## CITY OF TONTITOWN PLANNING OFFICE

Meeting: **March 26, 2019**  
Project: **Siena Townhomes 2**  
Planner: Courtney McNair

### i. **CONDITIONAL USE PERMIT REQUEST**

### ii. **PRELIMINARY LARGE SCALE DEVELOPMENT PLAN APPROVAL**

**LANDSCAPE PLAN**

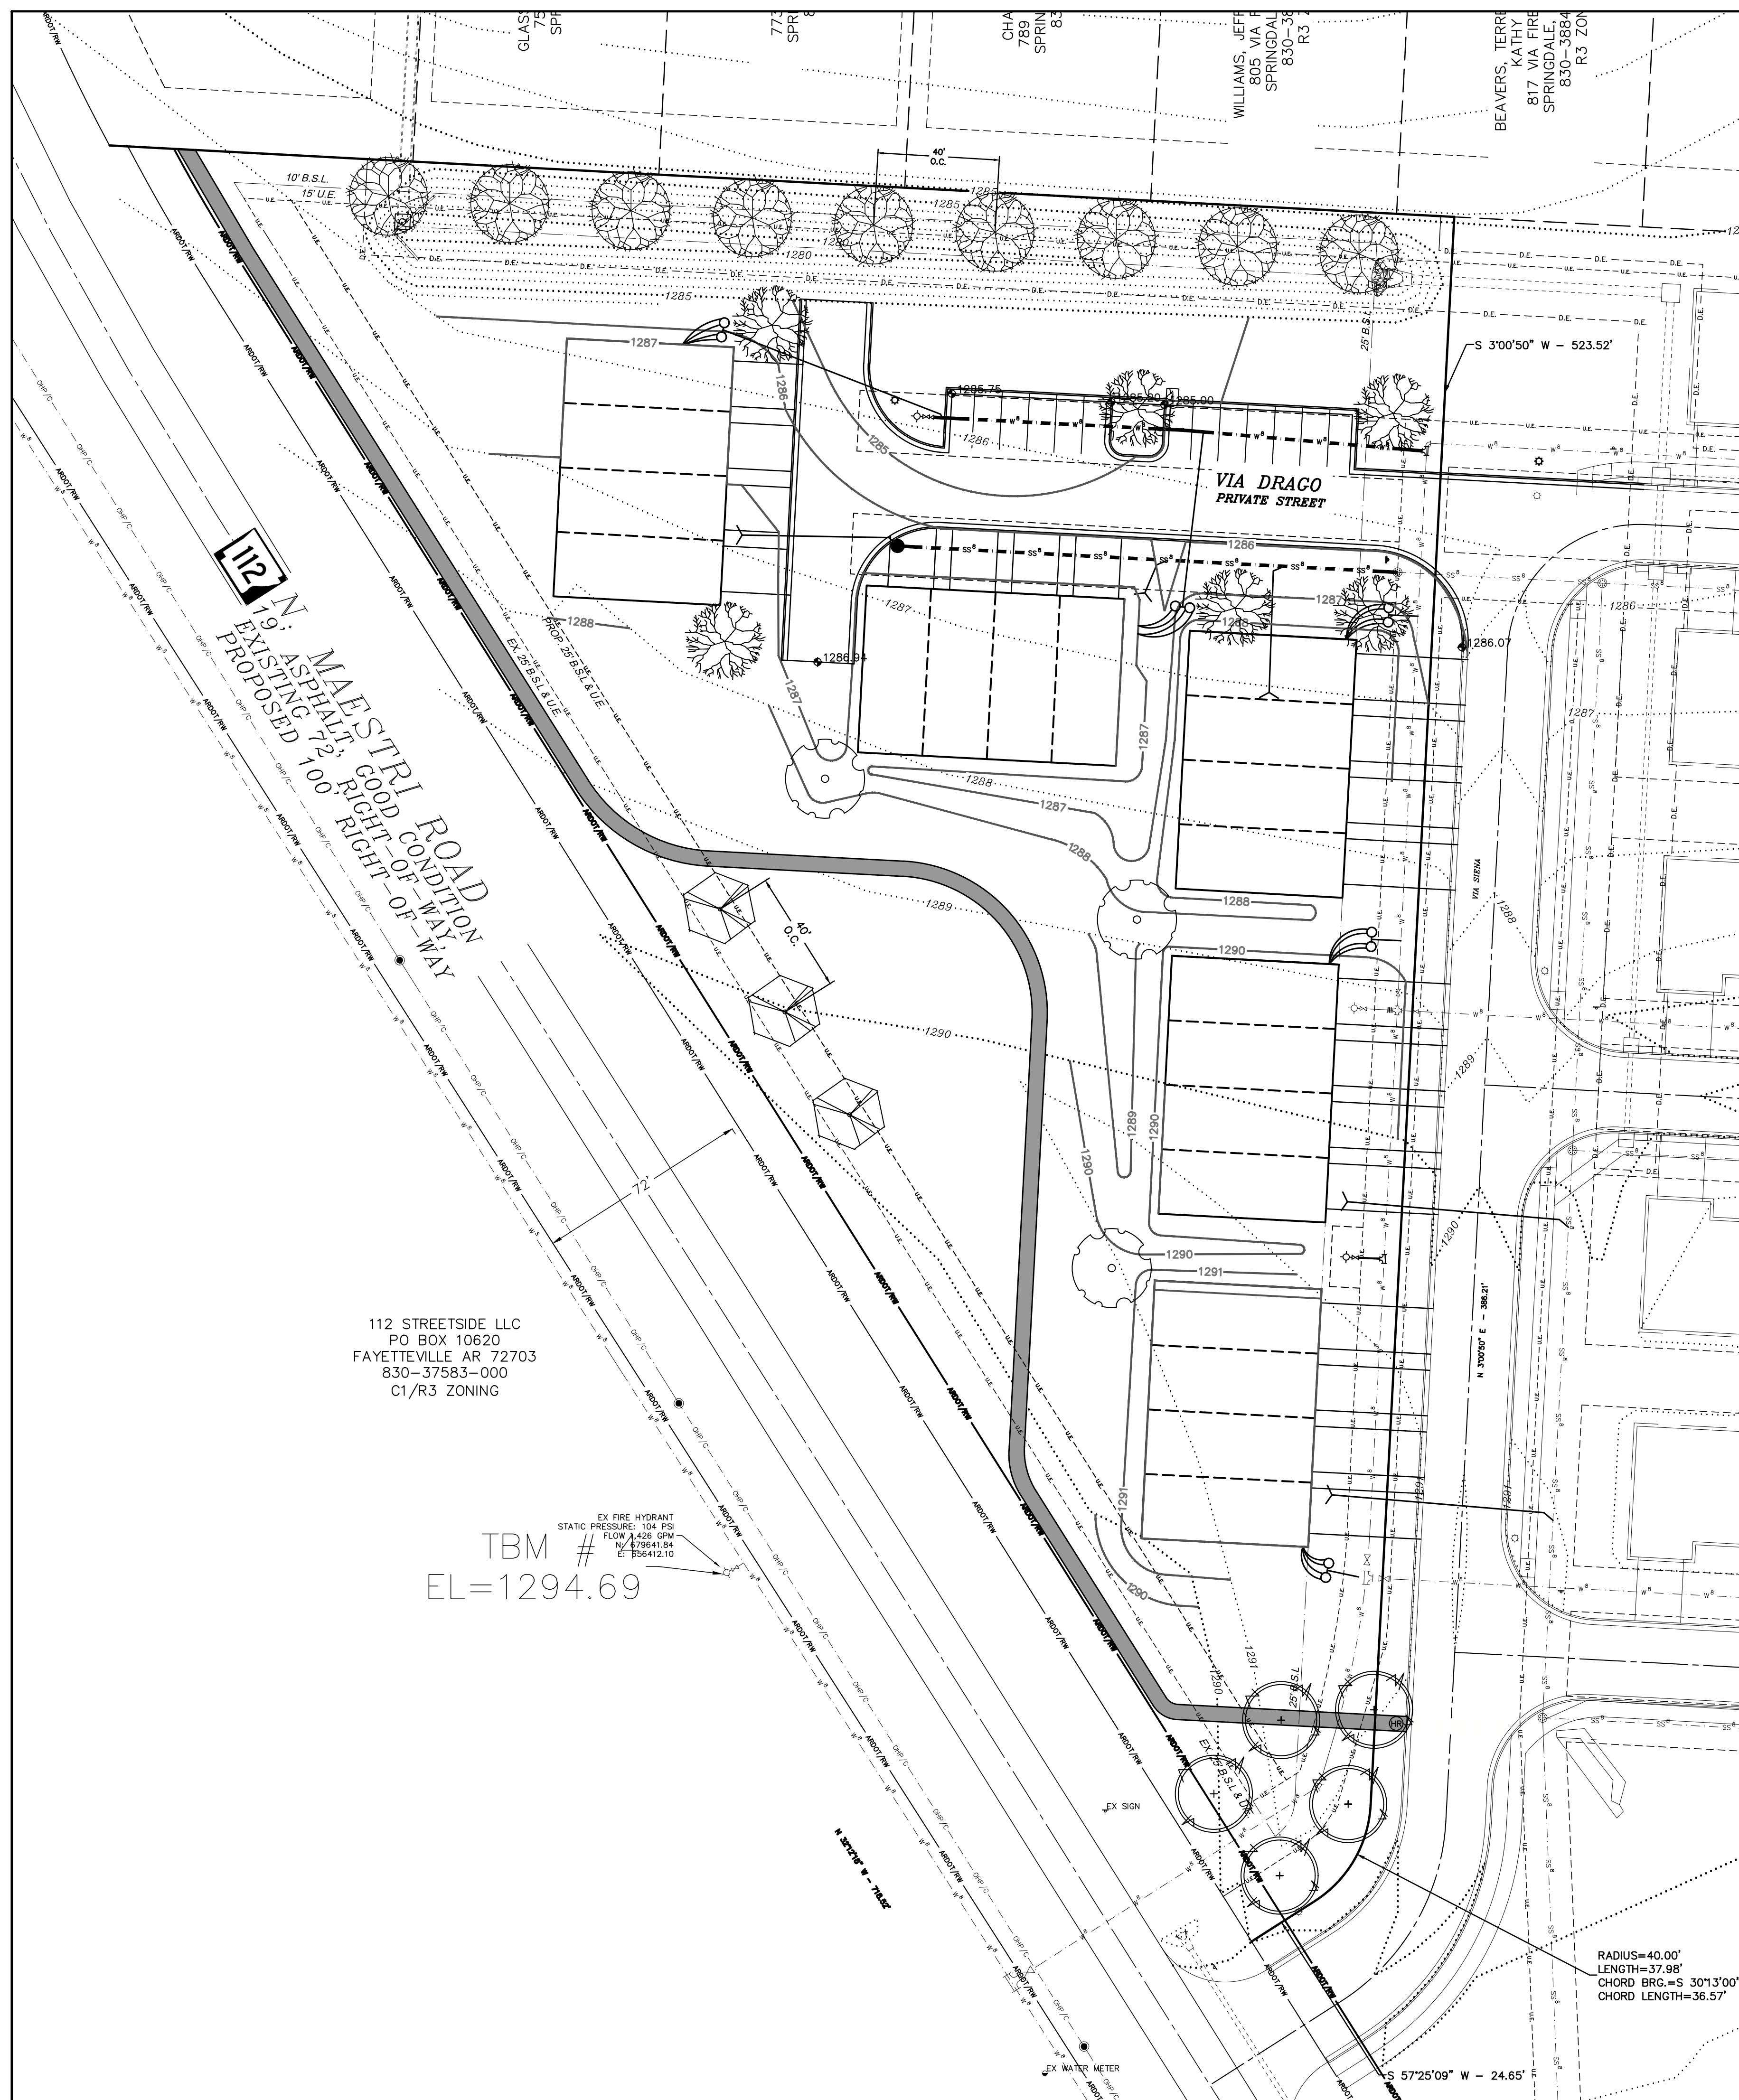
**The amount of greenspace shown on the concept plan appears adequate, although some of the plantings may need to be relocated out of the utility easements. The applicant is placing evergreens along the north line between the proposed project and the existing single-family residential development.**

The applicant is showing a 5-foot sidewalk along N. Maestri that meanders into the site. This must be increased to 6-feet in width to be in compliance with the Master Street Plan. Additionally, staff is not concerned overall with this placement, but will require that it continue along N. Maestri at the south of the site. Currently it is shown to turn to give access to the existing play area in Siena Townhomes Phase 1, but will also need to provide connection south along N. Maestri.

7. The sidewalk along N. Maestri shall be increased to 6-feet in width to be in compliance with the Master Street Plan.
8. The sidewalk shall continue along N. Maestri at the south of the site to provide connectivity to the south.

9. All facades facing N. Maestri shall be in compliance with the Large-Scale Development Architectural Standards.
10. Some of the plantings may need to be relocated out of the utility easements.
